Proposed Drawing Correction.

REMARKS

FIGURE 1

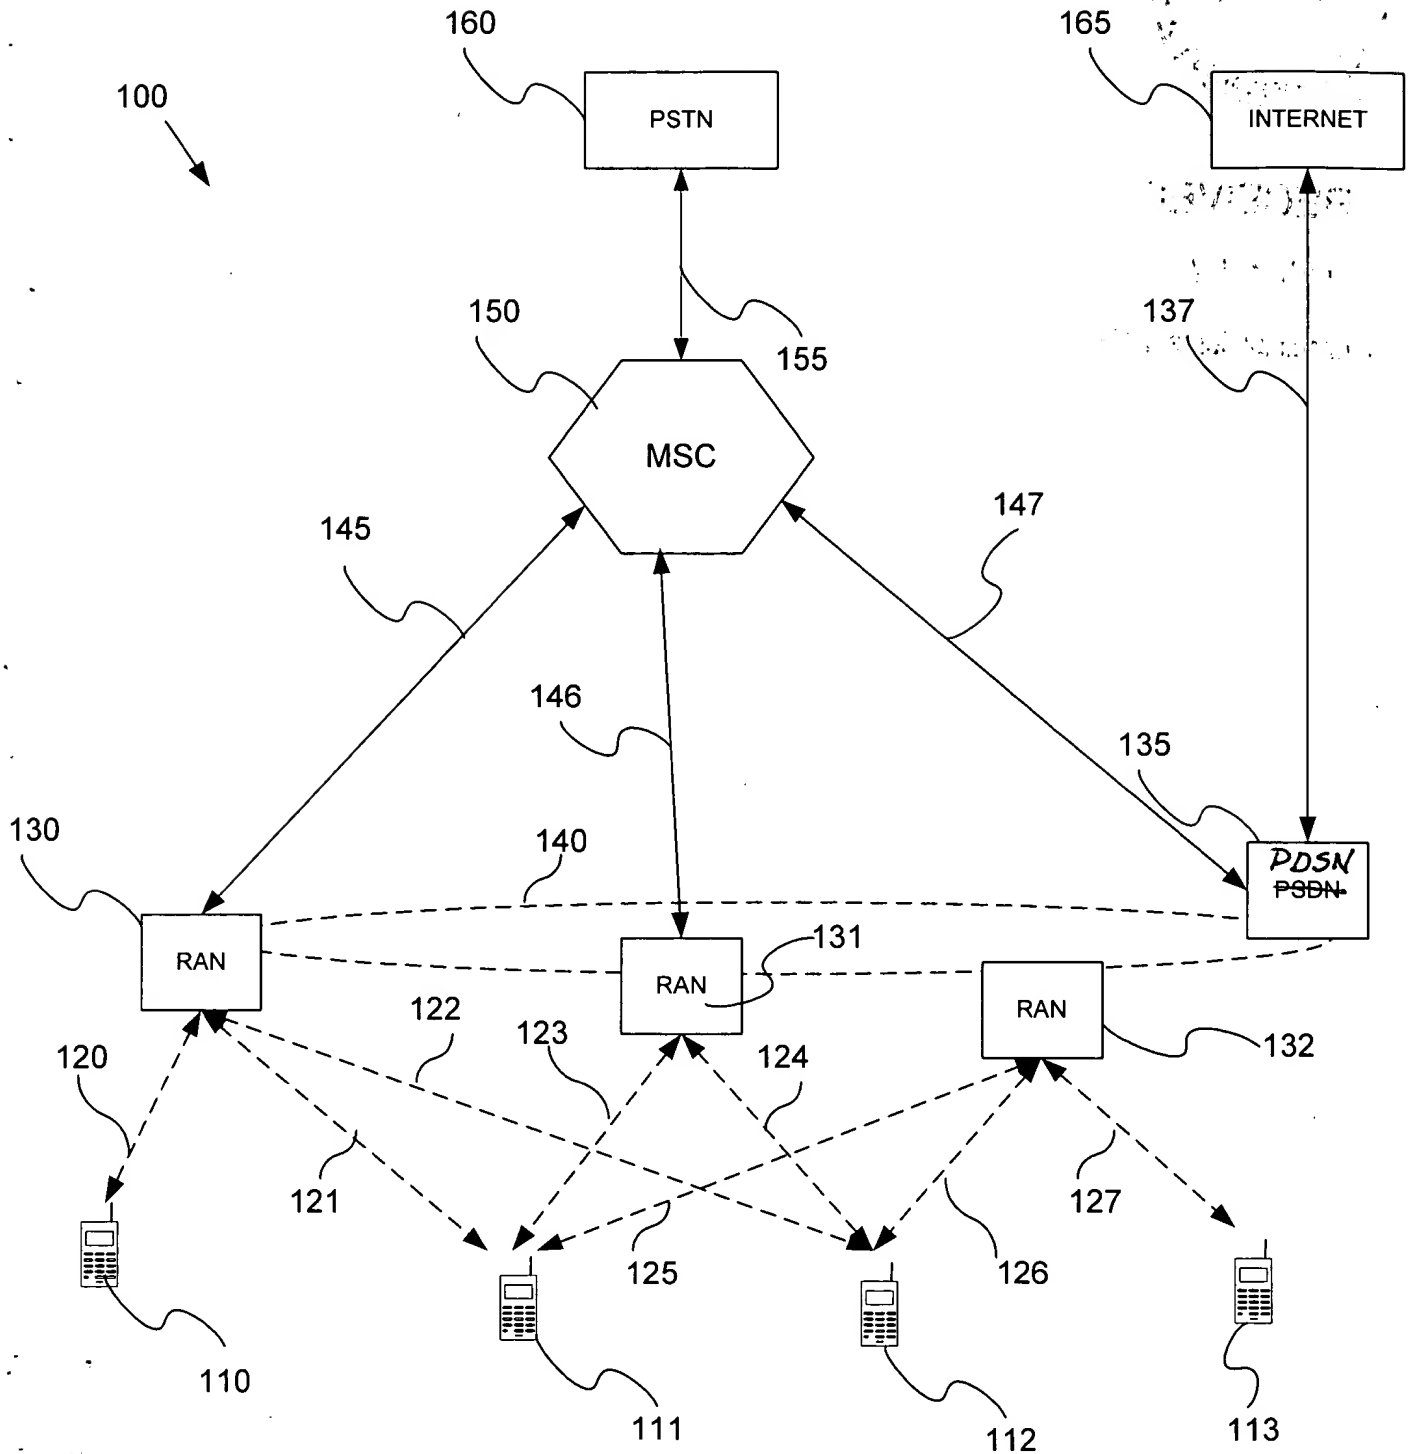
FIGURE 1 has been amended as indicated in red on a copy of FIGURE 1 as originally filed. Specifically, FIGURE 1 has been amended to correct a block identification from “PSDN” to “PDSN.” Support for this change may be found in the original specification beginning on page 11, at line 7, wherein it states: “Packet data server node PSDN 135 is a packet routing device that provides services and coordination between the subscribers in a wireless network and external networks, such as the internet 165.” No new matter has been added by this change.

FIGURE 2

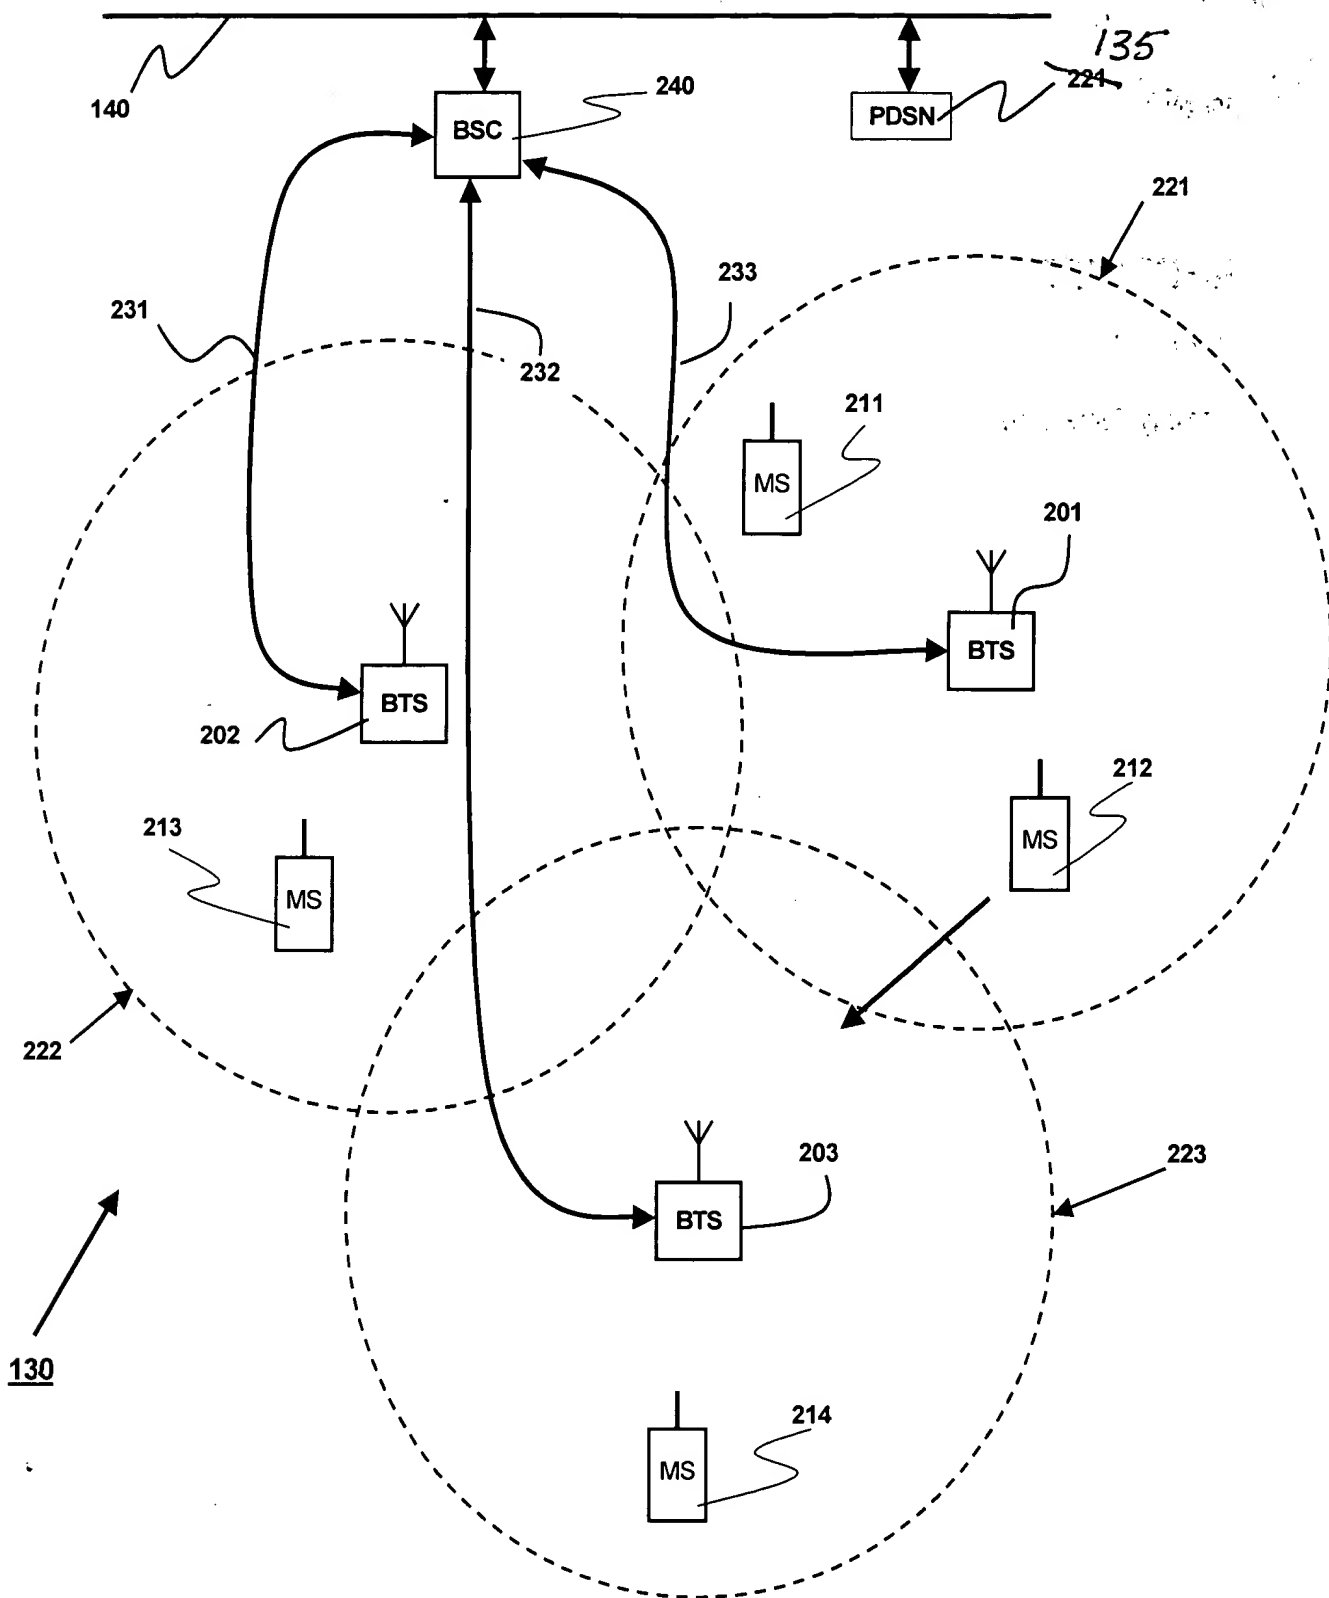
FIGURE 2 has been amended as indicated in red on a copy of FIGURE 2 as originally filed. Specifically, FIGURE 2 has been amended to replace label 221 with label 135 in the block diagram of a radio access node. Support for this change may be found in the original specification on page 11, at line 7, wherein it states: “Packet data server node PSDN 135 is a packet routing device that provides services and coordination between the subscribers in a wireless network and external networks, such as the internet 165.” No new matter has been added by this change.

FIGURE 3

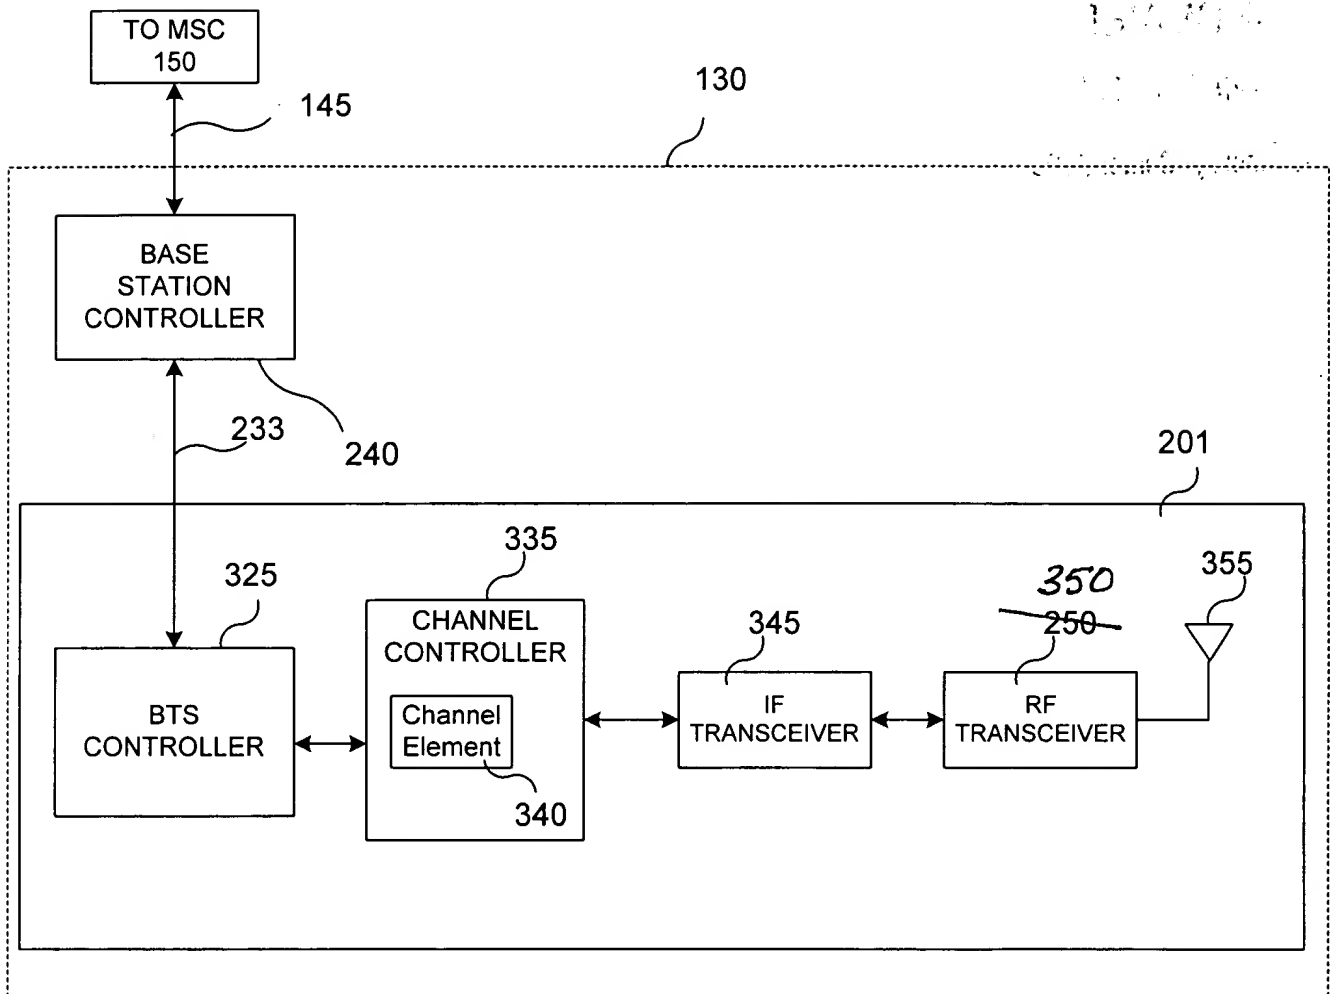
FIGURE 3 has been amended as indicated in red on a copy of FIGURE 3 as originally filed. Specifically, FIGURE 3 has been amended to replace label 250 with label 350 in the block diagram of a

radio access node in greater detail Support for this change may be found in the original specification on page 19, at line 3, wherein it states: "BTS 201 comprises BTS controller 325, channel controller 335, which contains representative channel element 340, transceiver interface (IF) 345, transceiver unit 350 and antenna array 355." No new matter has been added by this change.
